2023/PDP-1 (MAK)

SUBJECT: Application for an Interim Planned Development-Transit
(IPD-T) Permit - File No. 2023/PDP-1
Project: Chinatown Hotel Development
Landowners: Yee Hop Realty Limited, and
C.Q. Yee Hop & Company Limited
Applicant: Ikenakea Hokele LLC
Agent: Patrick Seguirant
Location: 128 North Nimitz Highway - Chinatown
Tax Map Keys: 1-7-002: 013, 023, and 050
Acceptance Date: October 26, 2023

DEPARTMENT OF PLANNING AND PERMITTING
OF THE CITY AND COUNTY OF HONOLULU

1 WEST ELEVATION

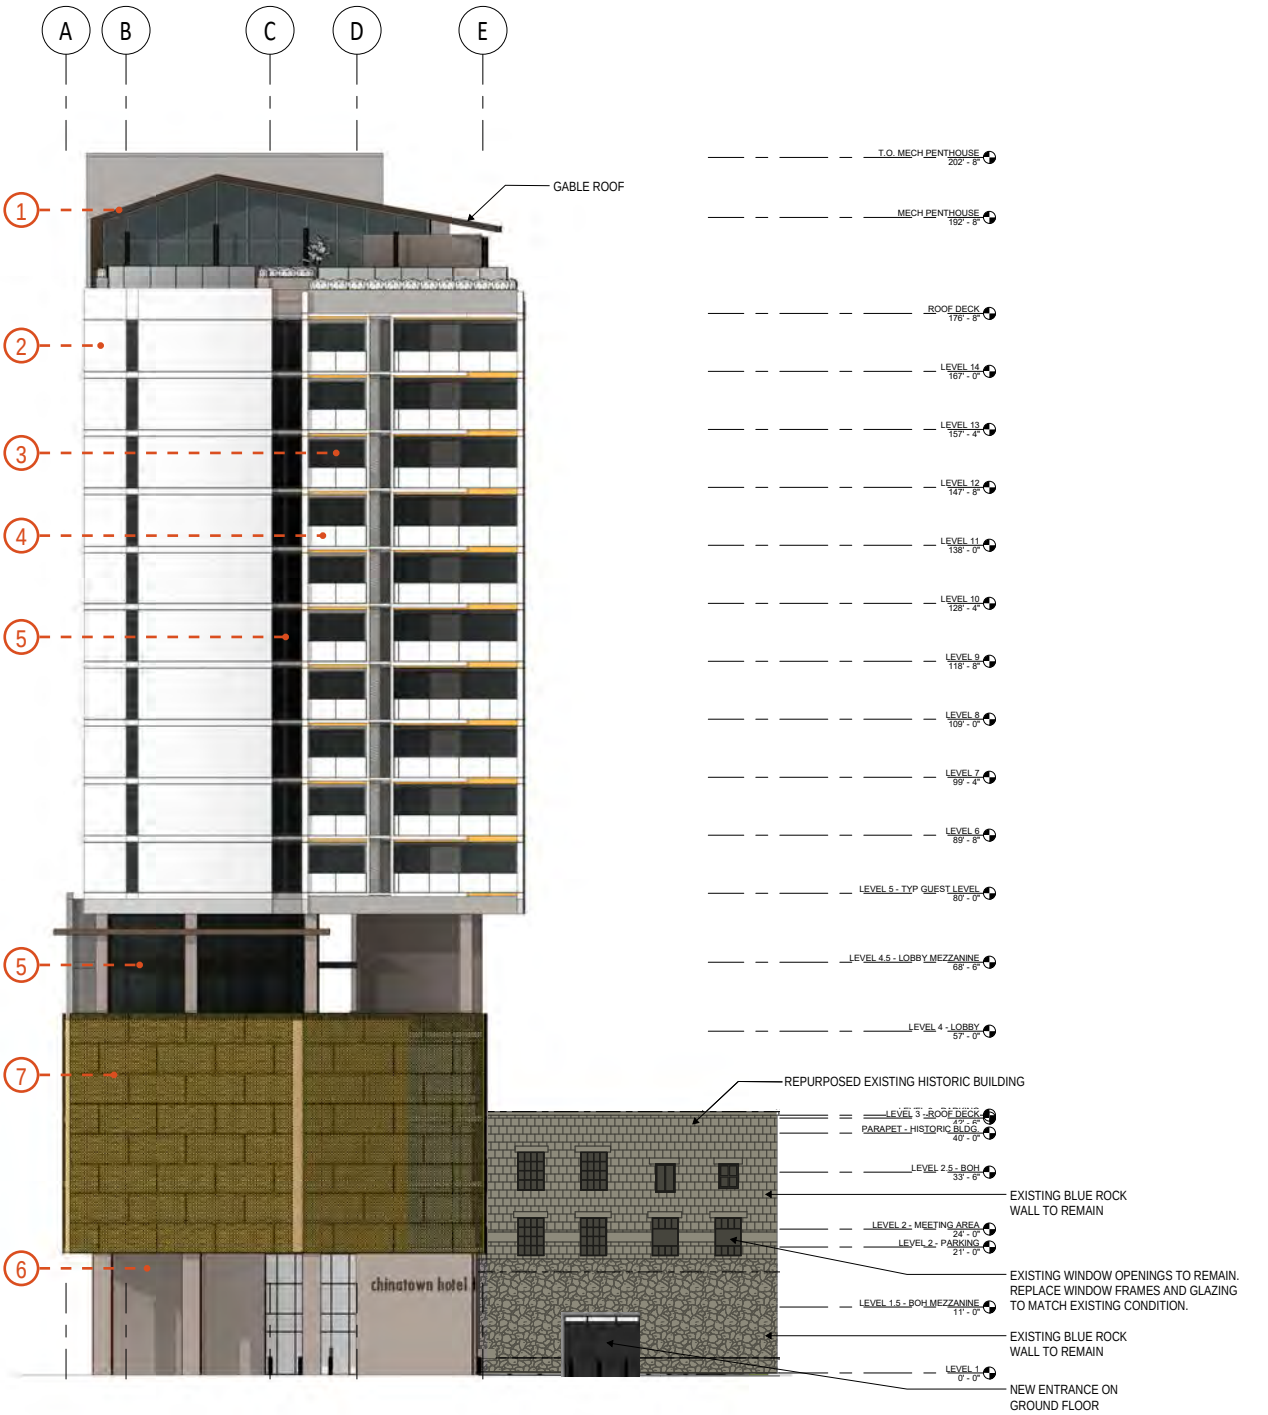
2. Maximum Height: Under the LUO and zoning maps, the maximum height limit for the site is 80 ft. The TOD Plan allows for a maximum height limit of 200 ft. for the site. Through the IPD-T Permit, the Applicant seeks to exceed the height limit by 120 ft. for the full allowance of 200 ft. The IPD-T provisions allow for this increased height if commensurate community benefits are provided to obtain the bonus. The Project proposes a 15-story tower where a five-story tower would otherwise be allowed. If the Project is approved as proposed, the bonus height will result in approximately 10 additional floors and approximately 125,667 sq. ft. of floor area above the height limit (see Exhibits C-11 through C-13). This will be further analyzed below.
